## STAFF REPORT

**SUBJECT:** **Easton Village 5<sup>th</sup> Addition – Easement Vacations and Final Plat**

To: Ken Roberts, Planning Director  
Cc: Chad Isakson, P.E., Assistant City Engineer  
From: Jack Griffin, P.E., City Engineer  
Re: Easton Village 5th Addition Final Plat  
Engineering Review Comments

**To:** Ken Roberts, City of Lake Elmo Planning Director  
**From:** Lucius Jonett, Wenck Landscape Architect  
**Date:** March 29, 2019  
**Subject:** City of Lake Elmo Landscape Plan Review  
 Easton Village 5<sup>th</sup> Addition, Review #1

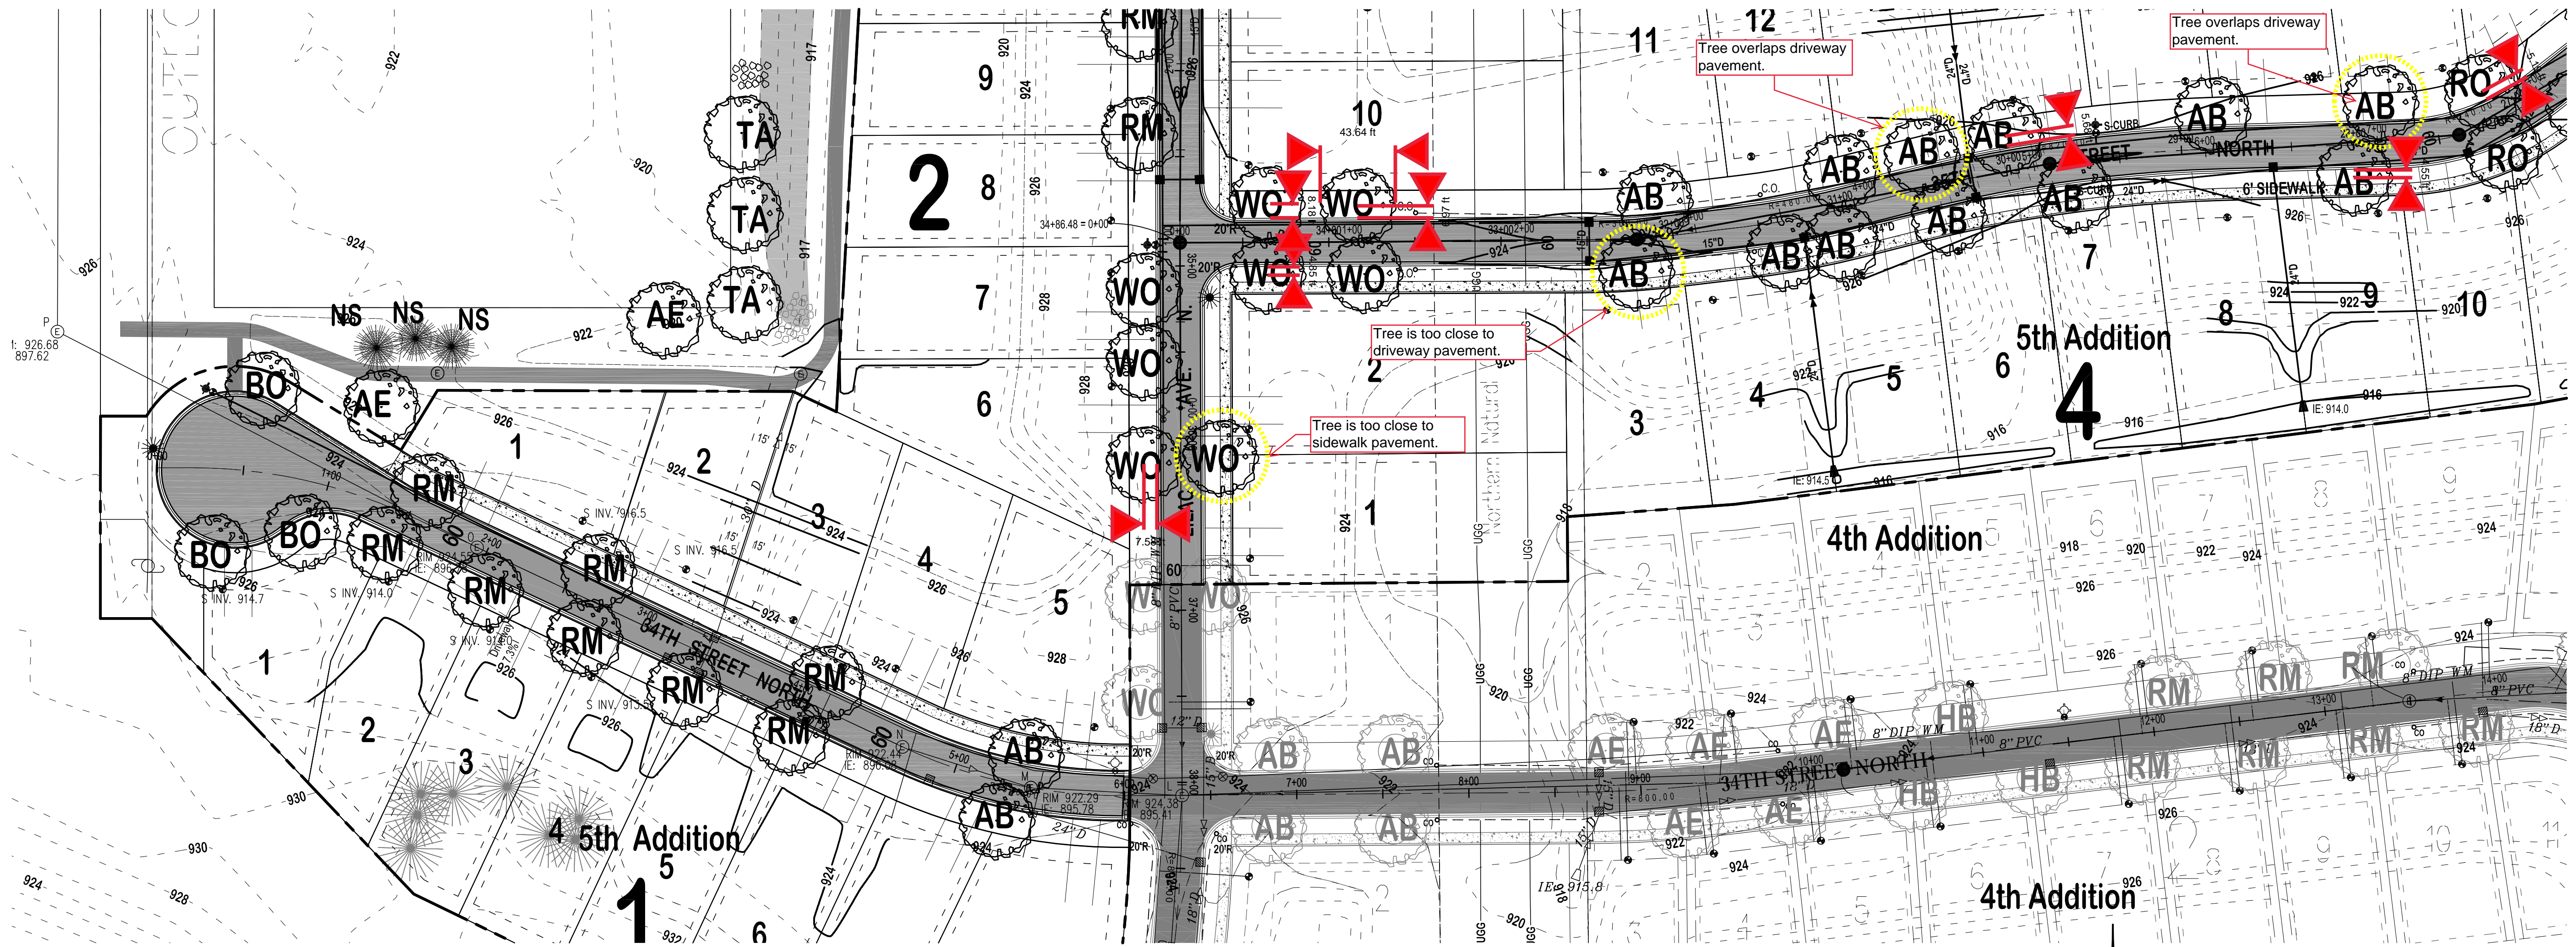
1. The increase of plantings along the railroad tracks is encouraged.
2. The reduction of plantings shown around the perimeter of the gas distribution station will not create open views from the homes on those lots to the distribution station. There are many existing trees on the Natural Gas Company property, not shown on the Easton Village plans. Reviewing Washington County GIS, the chain link fence and distribution station footprint is central on the property and surrounded by several rows of trees; all on the Northern Natural Gas Company property.

3. Several trees are shown over driveway pavement and need to be relocated. See attached figure highlighting the conflicts.
4. A few trees are placed within 10' of storm sewer utilities and need to be relocated to provide 10' from tree trunk to utility pipes.

5. Water and sanitary sewer utilities to the homes are not shown on the landscape plans and need to be included to show any tree placement conflicts.
6. Tree layout does not consistently match the typical ROW layout with boulevard trees 5' from back of curb when sidewalk is present and 8' from back of curb when no sidewalk is present.

7. City standard details are not used for planting details.

It is recommended that the conditions of approval include submitting a revised landscape plan showing the water and sanitary sewer utilities, including City standard details, and adjusting the tree layouts to resolve the conflicts noted in the findings above.
